WILLIAMSON COUNTY, TEXAS

CHANGE ORDER NUMBER: 22

Project Name: FM 3349 at US 79

**FM3349 at US 79
Williamson County Project No. 22IFB139**

TCP-TEMPORARY DETOUR PLAN AND PROFILE TMP-4

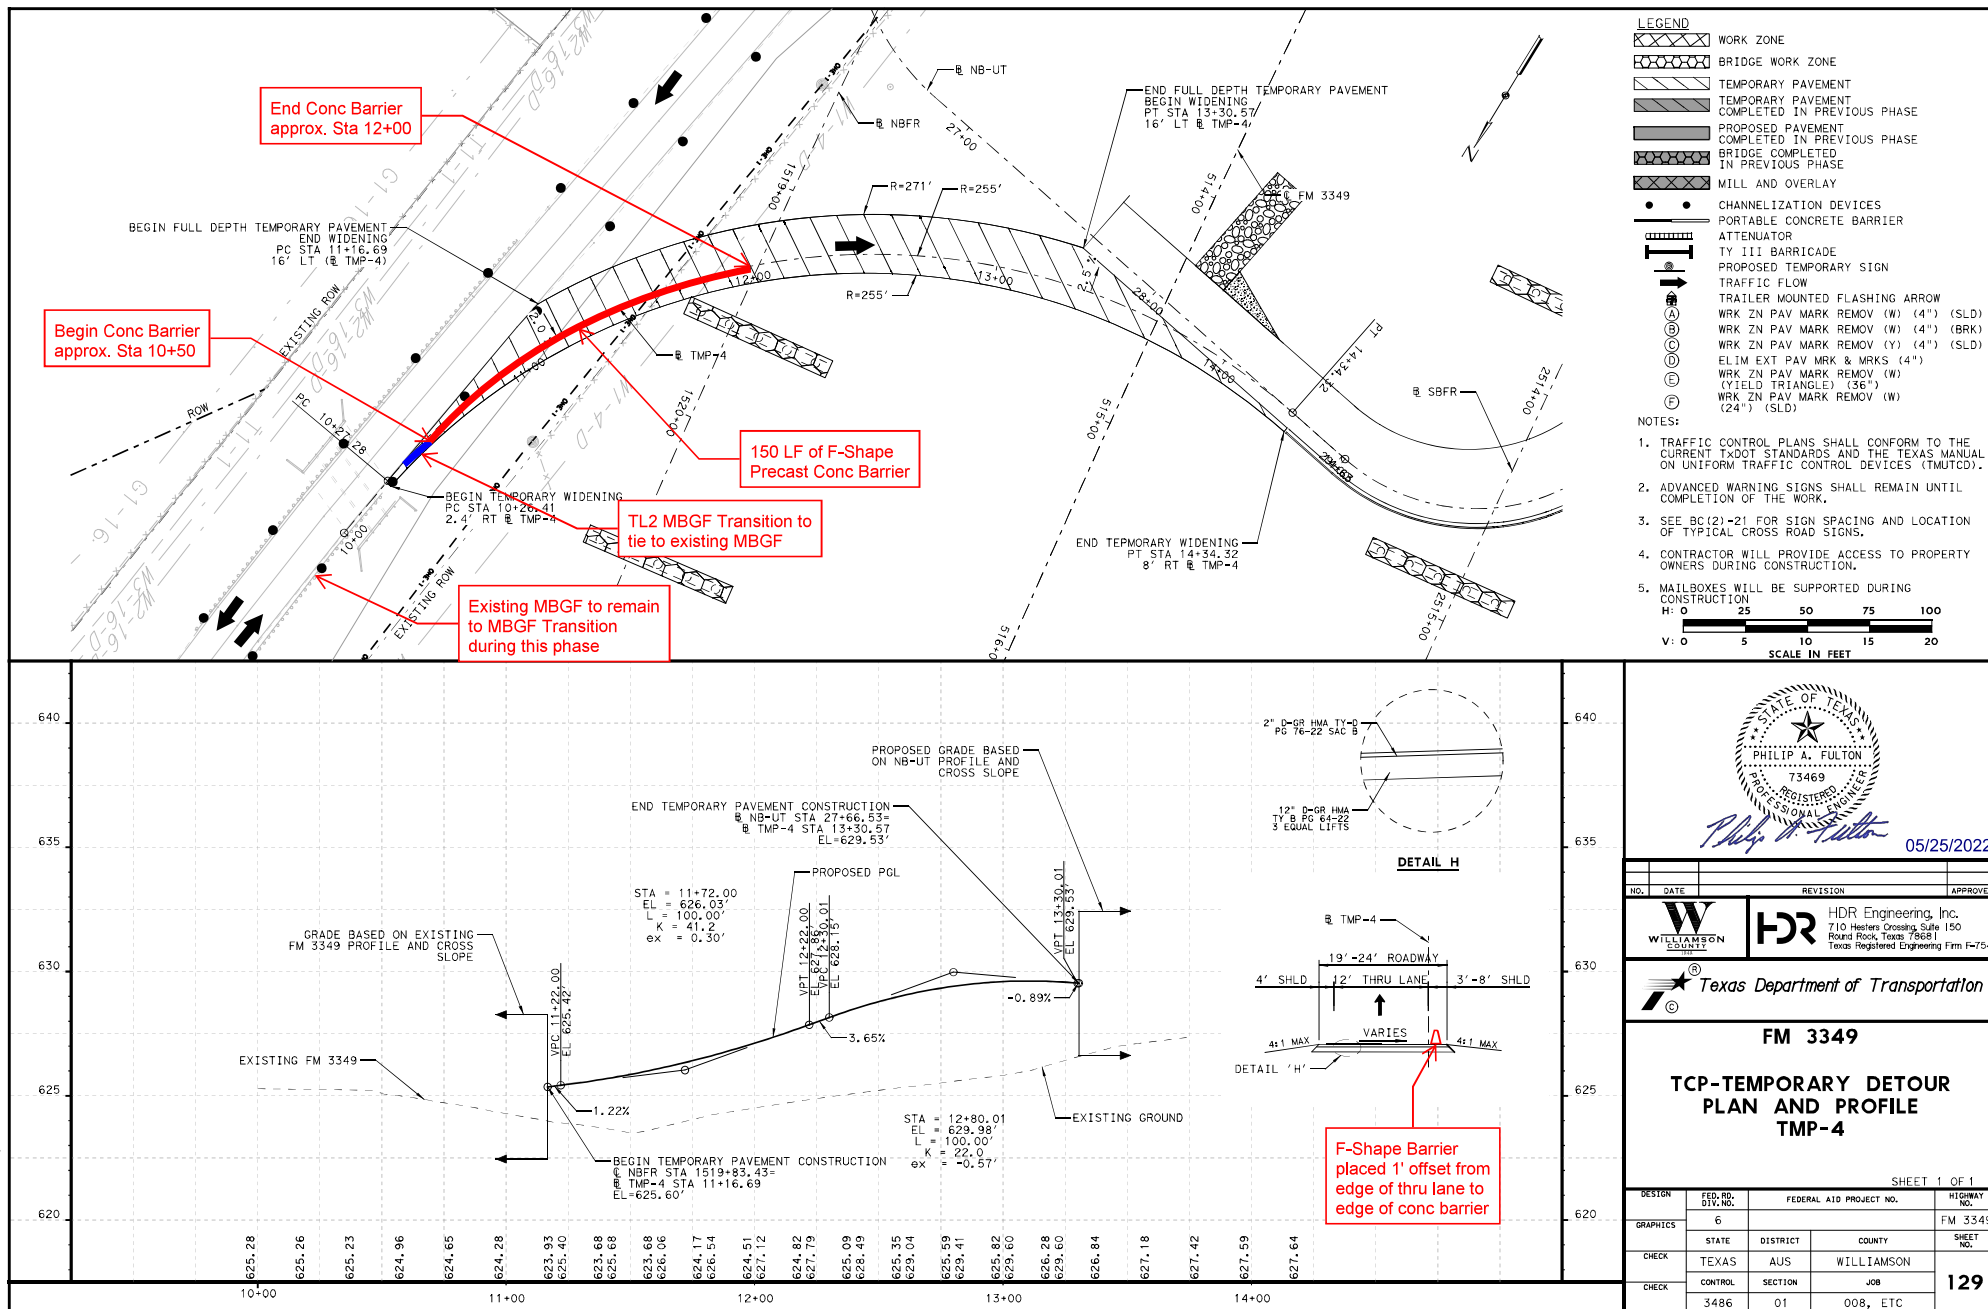
RFI Detail:
JCG has identified a couple of concerns with the temporary detour TMP-4 for diverting SB traffic on to SBFR. Referring to plan sheet 129 there is no barrier to protect the columns for bent 6 or the culvert C-UT-CV-01 located on either side of the detour. The other concern is the MBGF which will need to be moved and reset; however, the plans only call to remove. Please advise JCG on how HNTB would like to proceed and/or means and methods for resolution.

Response:
Attached are markups on Sheet 129 with our recommendation to shield the Bent 6 columns.
Signature: <u>Srikanth Koneru, P.E</u> Date: <u>11/11/2024</u>

Design Division Standard
METAL BEAM GUARD FENCE RAIL HEIGHT ADJUSTMENT (28" TO 31") TL-3 MASH COMPLIANT RAIL-ADJ(B)-19		
FILE: r010adjb19 NOVEMBER 2019 REVISIONS	DMT: TxDOT CONT: SECT DIST: COUNTY	CK: KM DMT: VP CK: CGL/AG HIGHWAY SHEET NO.

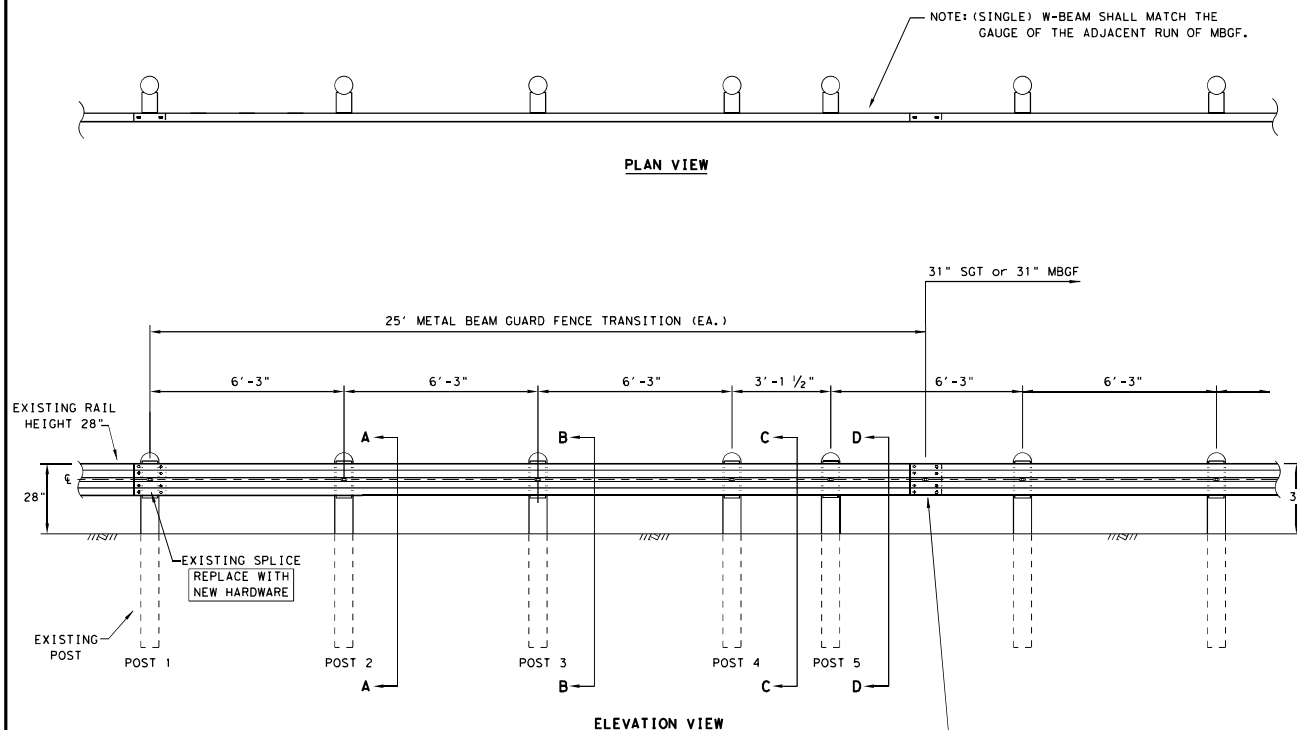
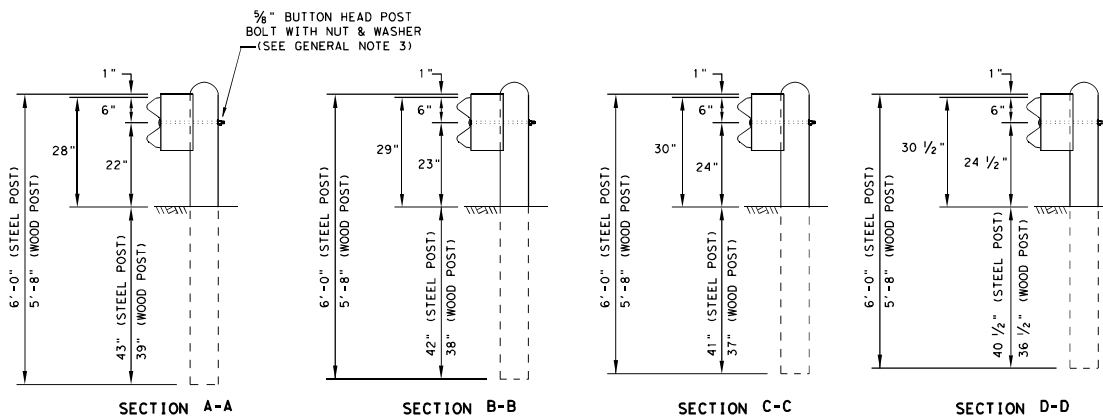
This Change Order compensates the Contractor for replacing a section of the existing metal beam guard fence (MBGF) on SB FM3349 to meet current TxDOT standards. This section of MBGF connects to the concrete barrier protecting the columns of the new bridge and its height needed to be adjusted to be MASH compliant. The original MBGF was installed according to an older TxDOT standard. The proposed adjustment ensures compliance with current TxDOT standards and improves safety of the traffic traveling south from existing FM 3349 to the new South Bound Frontage Road.
